**REGULAR MEETING OF THE
CITY OF ALVARADO PLANNING AND ZONING COMMISSION
104 W. COLLEGE AVE.
MAY 16, 2024
6:30 PM
AGENDA**

This letter is to inform you that the attached Lone Oak Addition Phase 1 final plat application provided on April 22, 2024 has generated the recommendation of disapproval from the Alvarado Planning and Zoning Commission due to the following comments not being adequately addressed to result in compliance with the Alvarado subdivision ordinance.

ENGINEERING PLANS
FOR
LONE OAK PHASE 1
CITY OF ALVARADO
JOHNSON COUNTY, TEXAS
MARCH 2024

City Engineer Remarks on Preliminary Plat and Preliminary Engineering

Sheet 1 of 3

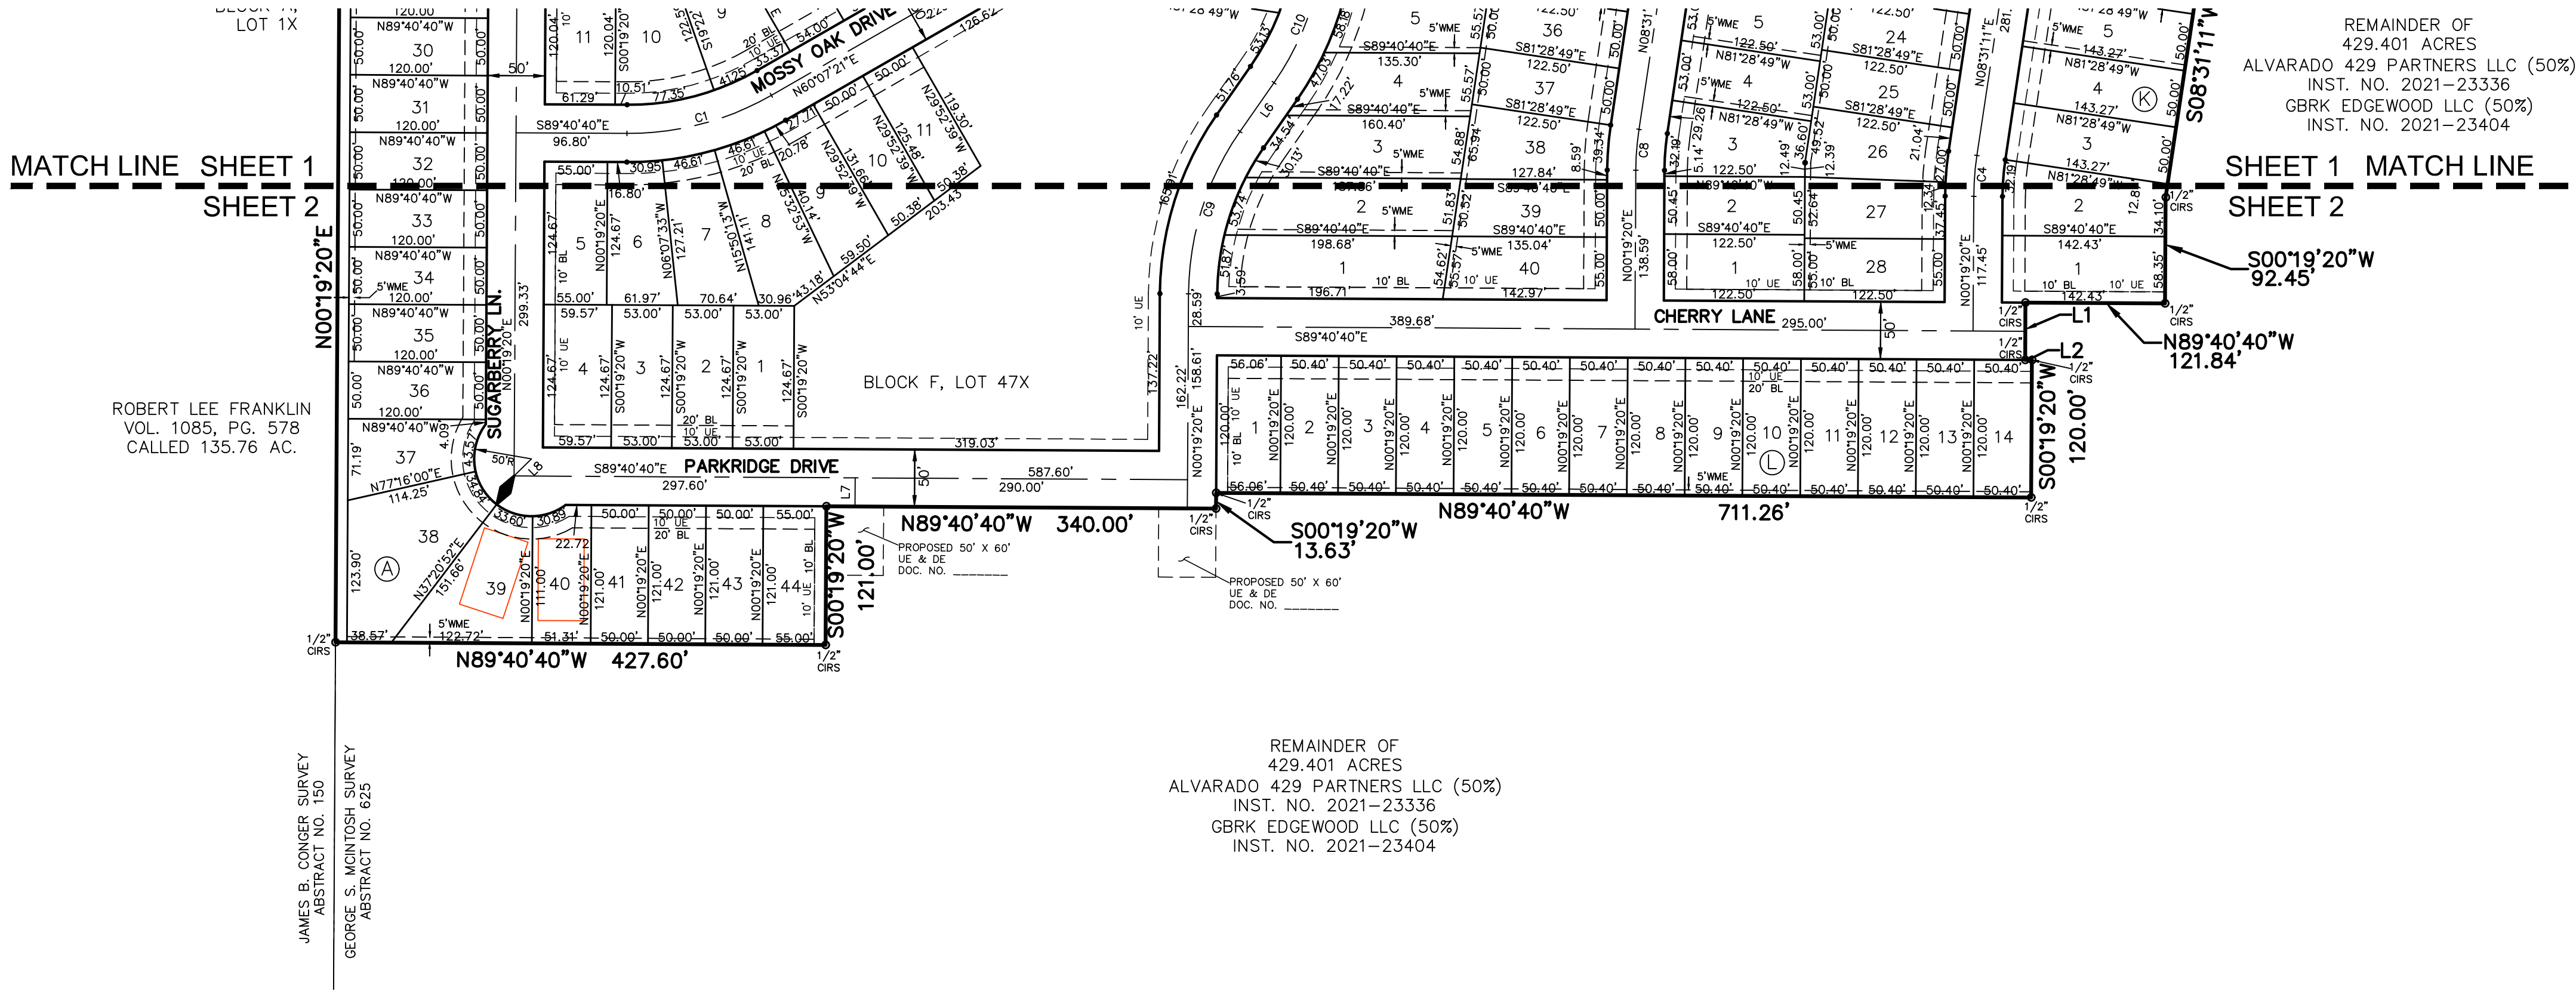
1. Clarify where on-street parking at the amenity center has been approved. The Alvarado zoning ordinance only allows on-street parking in the Central Business District.

2. On the final plat, change “(Unrecorded Right-of-Way)” to “Right-of-Way Dedication”.
3. Prior to final plat approval, adequate capacity to and at the Alvarado Wastewater Treatment Plant must be accessible to comply with the purpose of the Alvarado subdivision ordinance. The purpose of this chapter (Alvarado subdivision ordinance) is to provide for the orderly, safe, and healthful development of the area within the City and within the area surrounding the City and to promote the health, safety, morals, and transportation, water, drainage, sewage, and other facilities per Art. I, Sec. 34-4(b) of the Alvarado subdivision ordinance.

7. Correct the leaders and location of the 5' WME along the side property line of Lot 21, Block J.
8. Provide the recording information for the offsite 15' SSE to the lift station.

9. Provide the recording information for the two offsite 50'x 60' UE and DE.
10. In the title blocks, owner's certification block, dedication statement, and owners signature block, update the ownership of record.

11. The surveyor's certificate needs not have a notary statement following.
12. Add the City's approval block for the Mayor to sign and the City Secretary to attest.

13. In the plat drawing, label "Private Open Space" on Lot 1X, Block A, and Lot 47X, Block F, and Lot 166X, Block C. Per Sec. 34-173(b) of the Alvarado subdivision ordinance, the specific use for which each piece of land is to be reserved must be shown by appropriate label or description on the subdivision plat.

14. Per Sec. 34-167(l) of the Alvarado subdivision ordinance, rear and side driveway access to major thoroughfares shall be prohibited. Add note stating such to final plat.

15. Per Sec. 34-170(a) of the Alvarado subdivision ordinance, easements alongside and rear lot lines shall be properly sized according to the municipal and other infrastructure (ie. natural gas, electric, cable, telephone, etc) necessary. The final plat shall be provided to appropriate utility companies for review and comment. Clarify what, if any, offsite utility easements to be dedicated by separate instrument will be necessary to extend natural gas, electric, cable, telephone, etc to subject site.

16. Per Sec. 34-66 of the Alvarado subdivision ordinance, the developer shall install sidewalks within and adjacent to the subdivision. Clarify if sidewalk construction is proposed and by whom if so along the subject site's frontage to CR 508. Include civil plans for sidewalks adjacent to the subdivision or provide cash deposit or other guarantee acceptable to the City for the payment of the cost of such sidewalk installations prior to City Council approval of the corresponding final plat.

17. Per Sec. 34-66(14) of the Alvarado subdivision ordinance, the developer shall install traffic signs, street signs, and sidewalks within and adjacent to the subdivision, or shall provide cash deposit or other guarantee acceptable to the City for the payment of the cost of such installations prior to the final approval by the City Council.

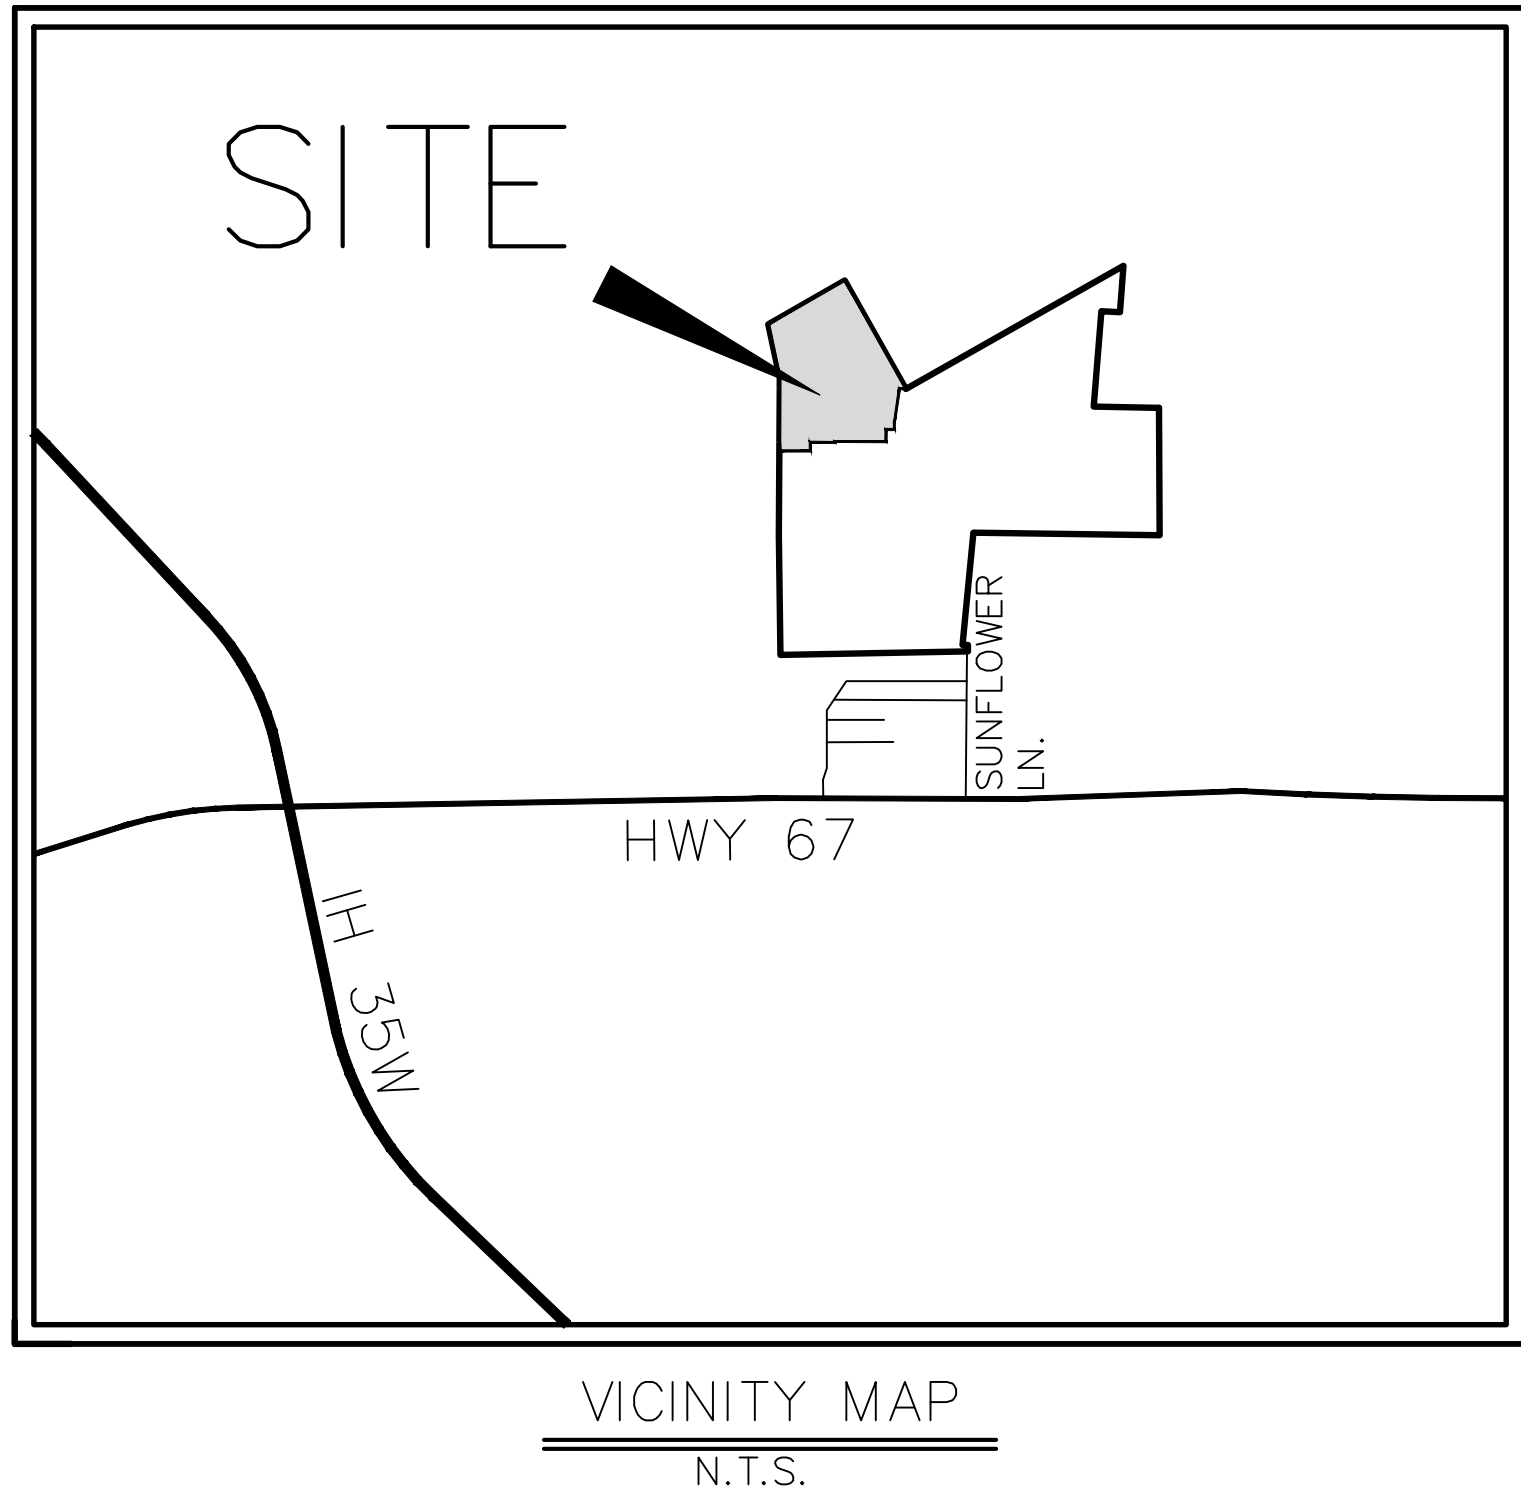
Include plans for improvements to CR 508

Verify compliance with all City Masterplans.

City's sanitary sewer system will not have additional capacity until the WWTP improvements are complete.

Downstream sanitary sewer lines are required to be installed and accepted by the City prior to any sewer service being available to this site. (or capacity provided in accordance with the agreement between the City and the development)

Verify with City if roadway or utility stub-outs to adjacent properties or Baugh Drive are needed.

TYPICAL SECTION OF SIDEYARD SWALE W/ WALL
N.T.S.

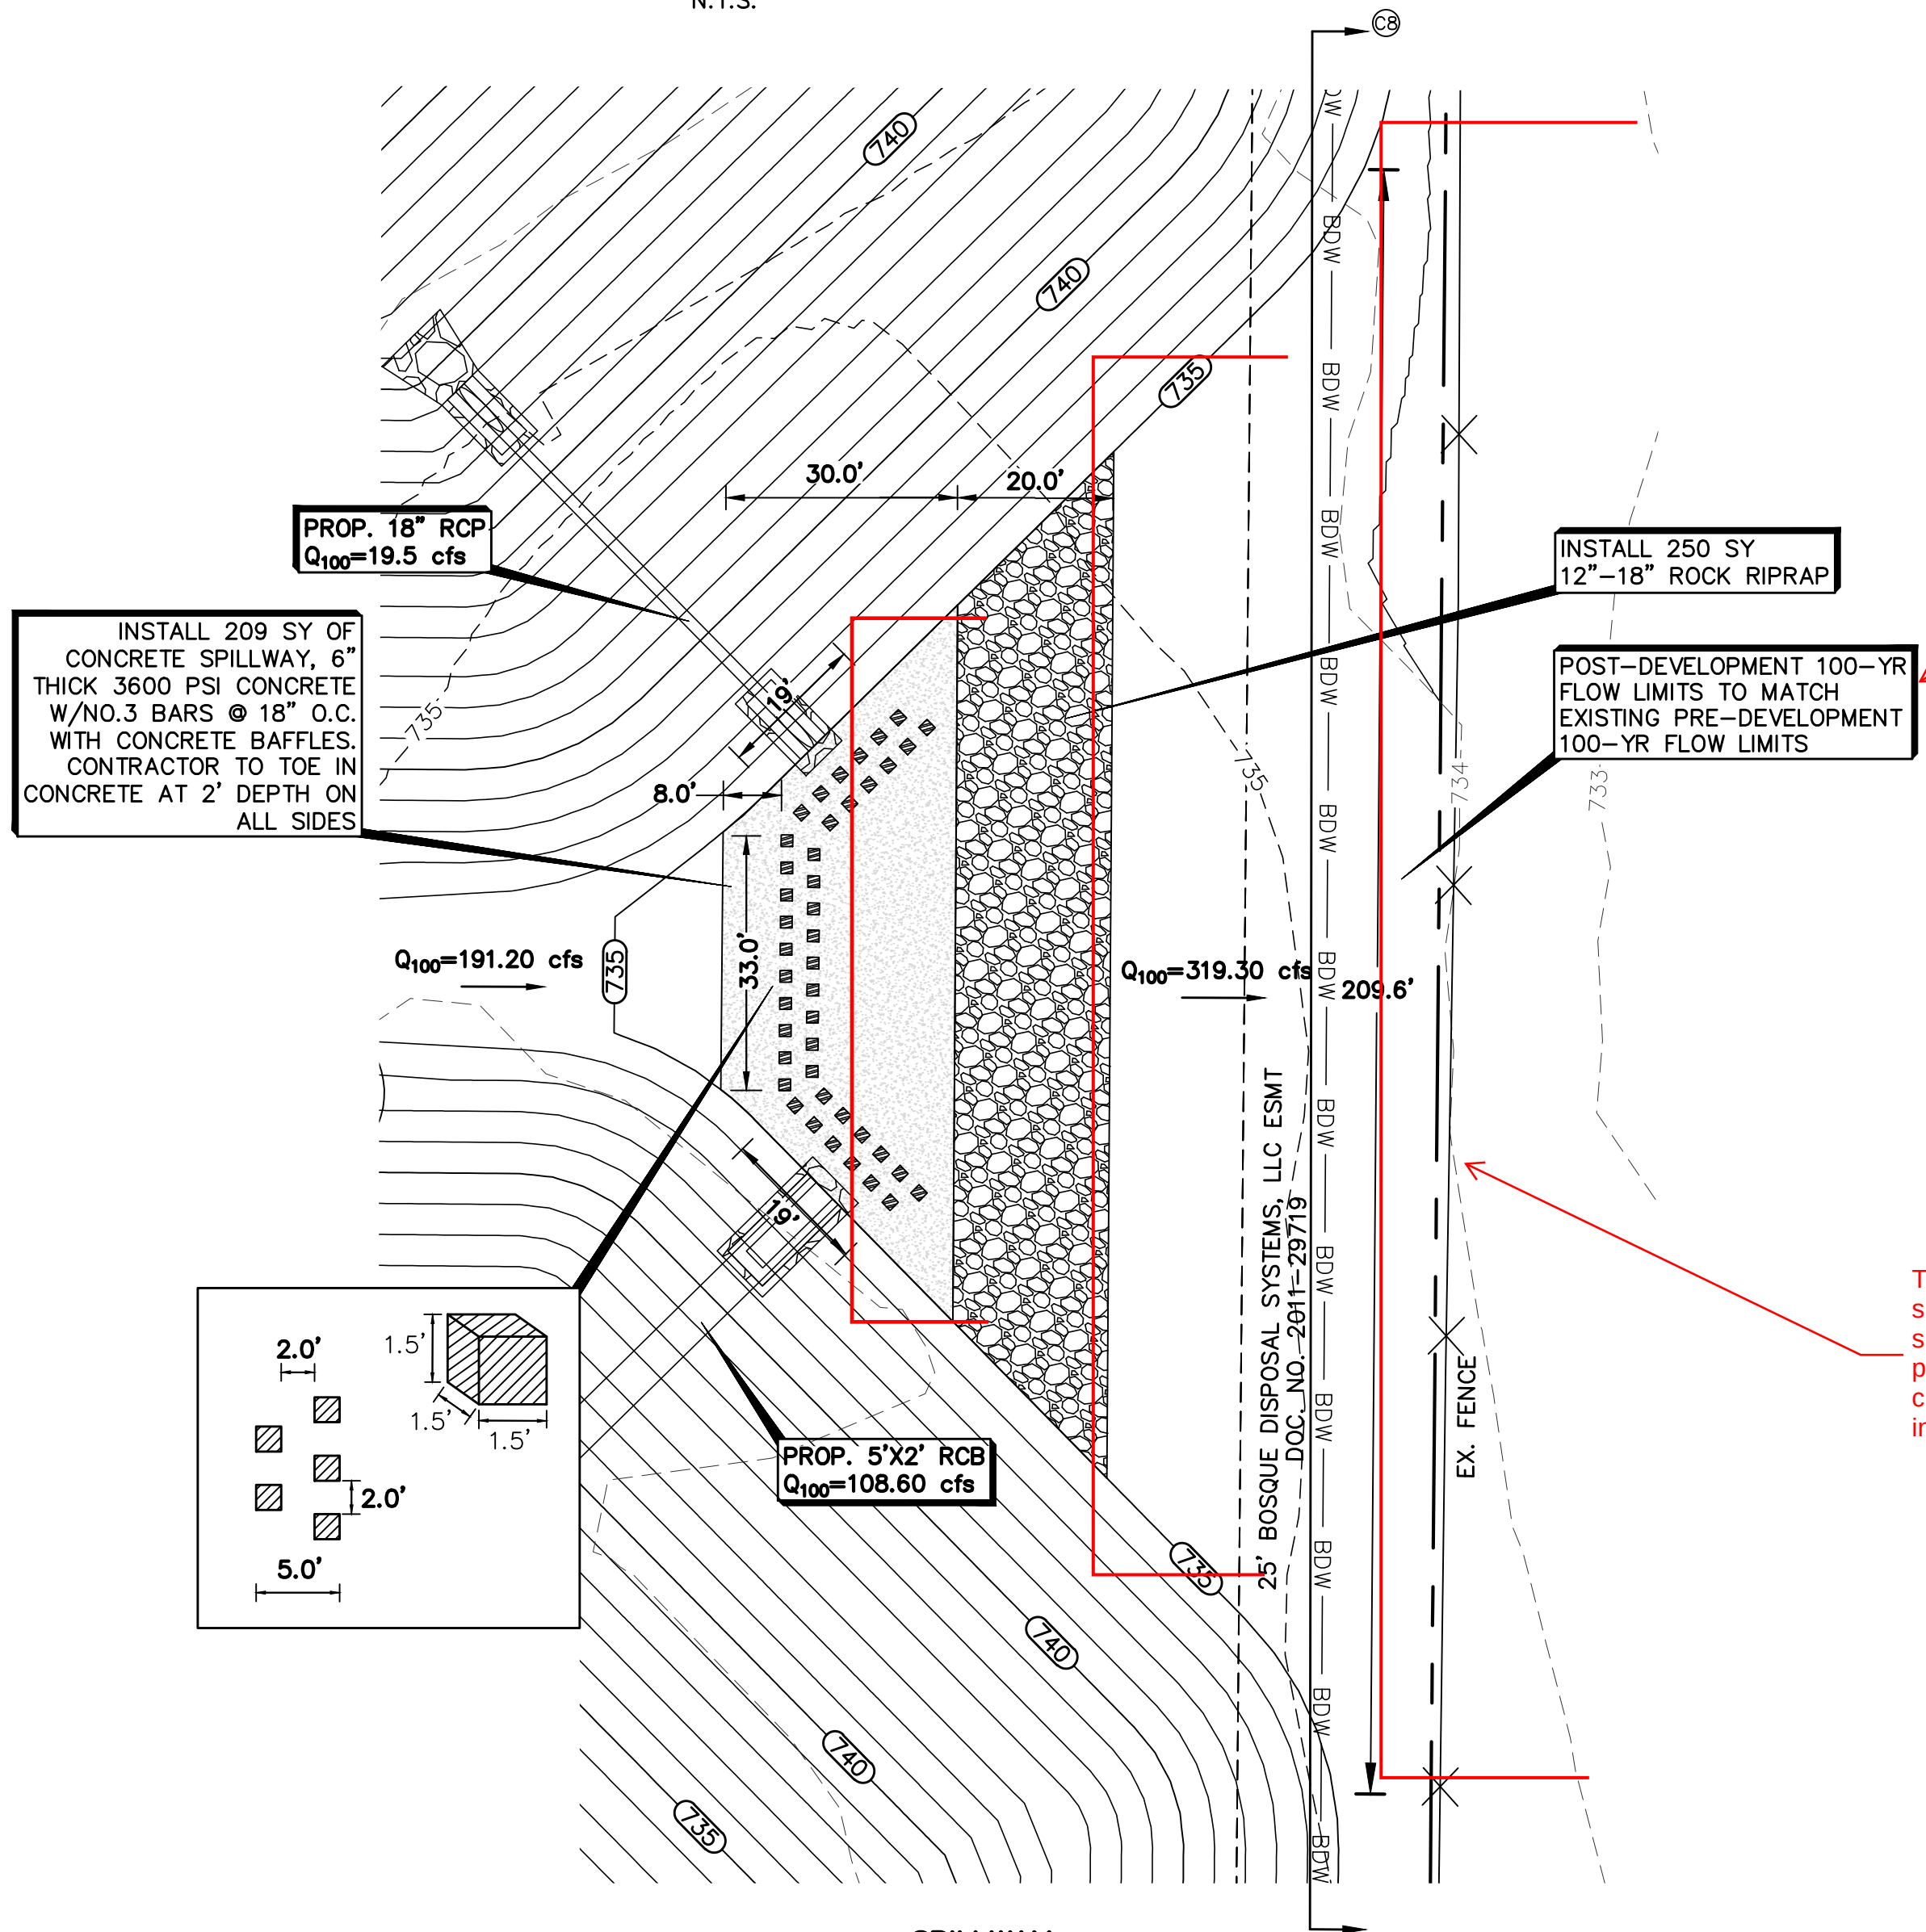
Label the flow rates

To be able to clearly show the attempt to spread the flow, provide cross-sections at increments
